I-180 Enhancement Project - Bridge Section – Final Report

Cheyenne MPO

December 30, 2005

Conceptual Railing
Bridges over UPRR
I-180, M.P. 9.37
Structure Nos. EAI and EAJ
Laramie County

Figure 5. Bridge Rail Alternative C

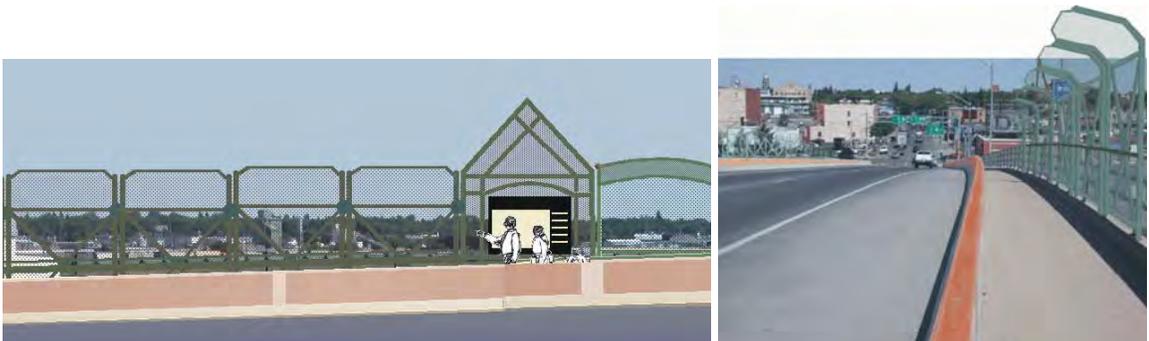
Alternative C: Alternative C borrows visual cues from the rich railroad heritage of Cheyenne. The fence has a bridge truss work like appearance. Alternative C is illustrated in Figure 5.

TYPICAL PANEL ELEVATION
(Looking Out From Sidewalk)

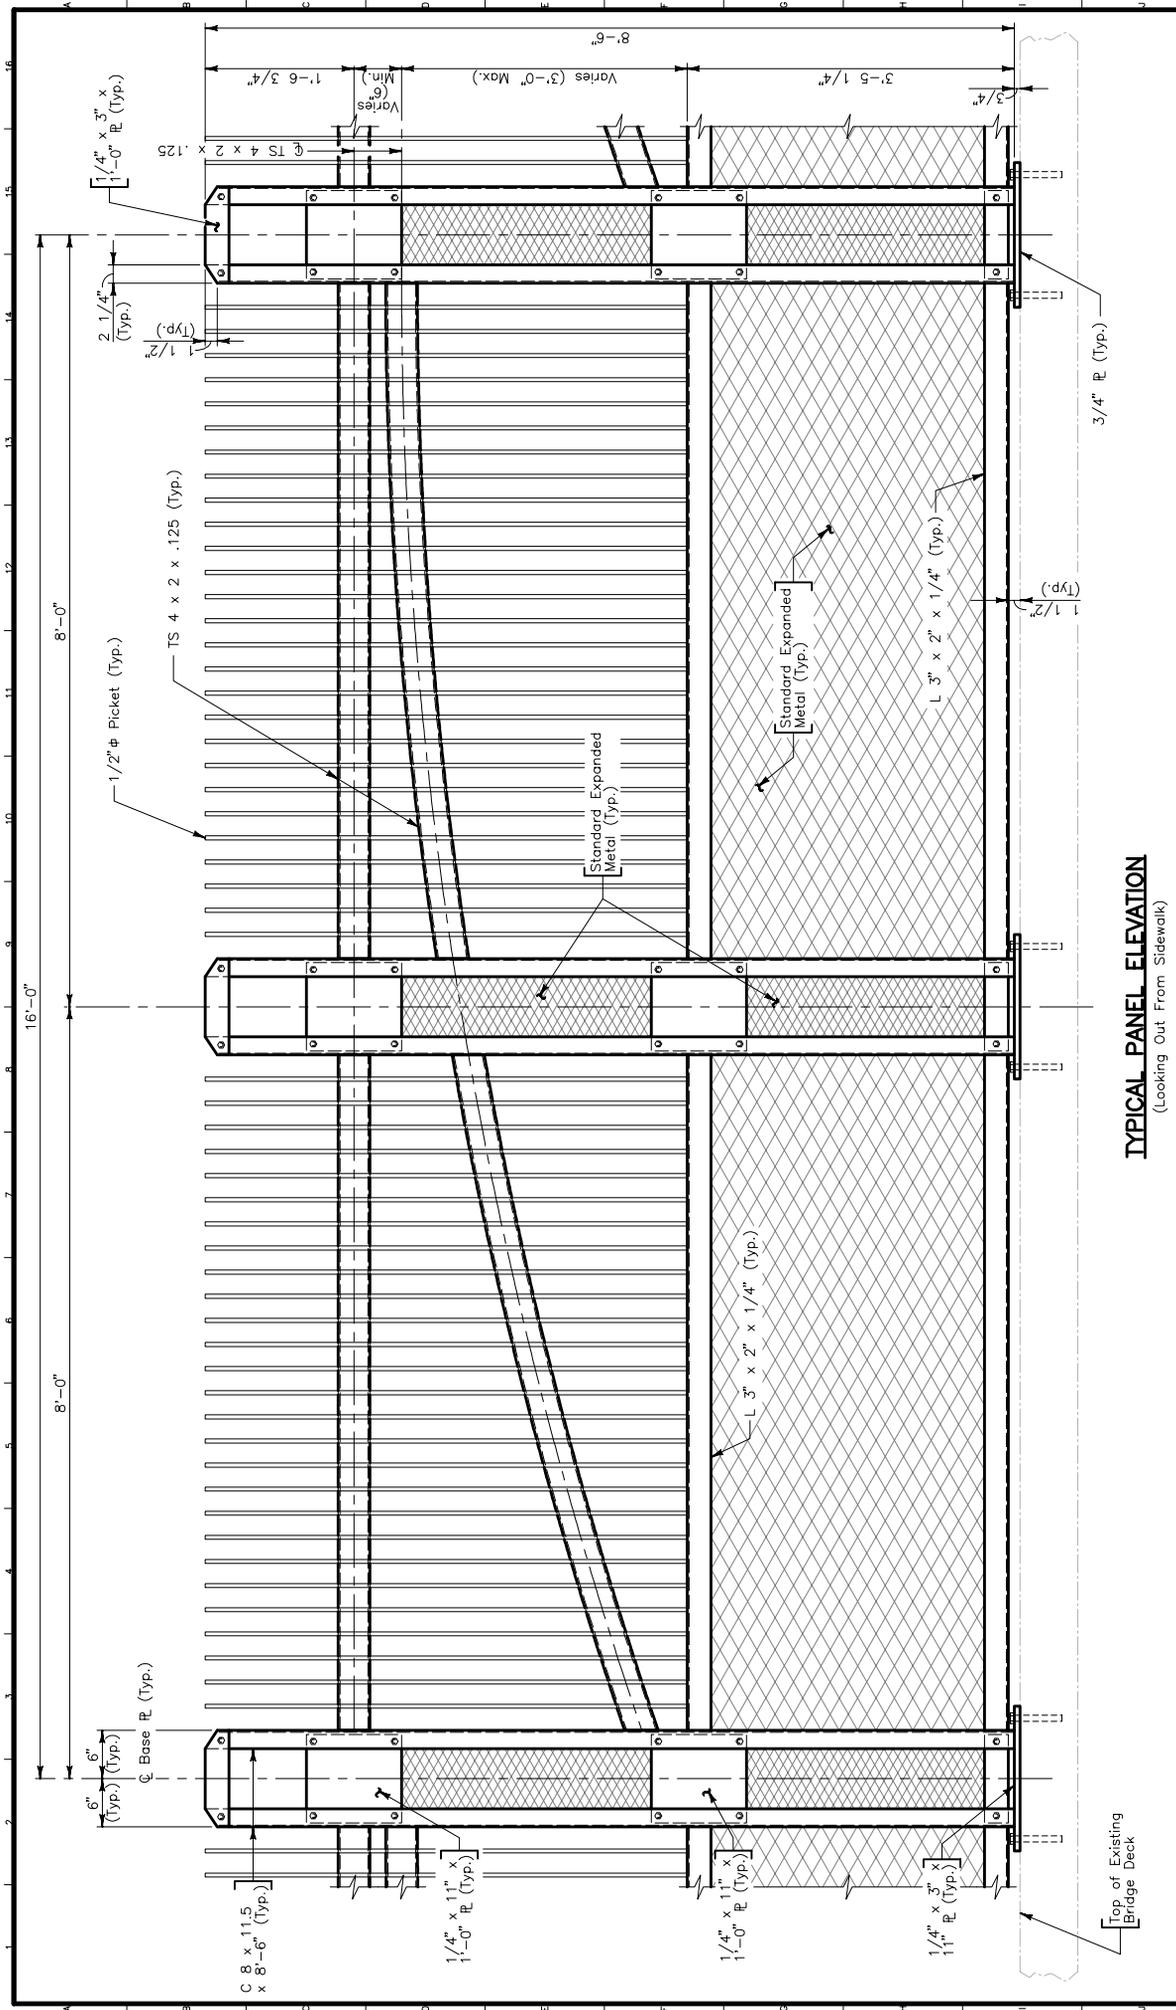
- The clear sidewalk width should be maintained and the railing should meet all ADA requirements.
- Neither the post spacing nor the anchor bolt anchor bolt arrangement of the new railing matches that of the existing. If this is the case, details for new anchorage and removal of the existing anchorage will be necessary.
- The ½" vertical pickets appear to be welded to the back side of the horizontal rail elements. This provides easy access for pedestrians to climb the railing.
- WYDOT is in the preliminary design stage for upgrading the lighting on this structure. The final railing design will need to be coordinated with this effort as WYDOT will need access to the poles and conduits for maintenance activities.

- 4) One of the goals outlined by the U.P.R.R. was to install a fence so that anyone contemplating suicide would not be able to do so from these structures. I believe some of the horizontal members within the proposed rail would allow individuals to scale the fence, as has occurred within the decorative rail placed on the TREX projects in Colorado.

Based on WYDOT comments, the conceptual rail design was altered to accommodate the vertical pickets in front of the horizontal rail elements. This will help to keep pedestrians from climbing on the railing. Copies of the correspondence with WYDOT and UPRR are included in the appendix for reference.
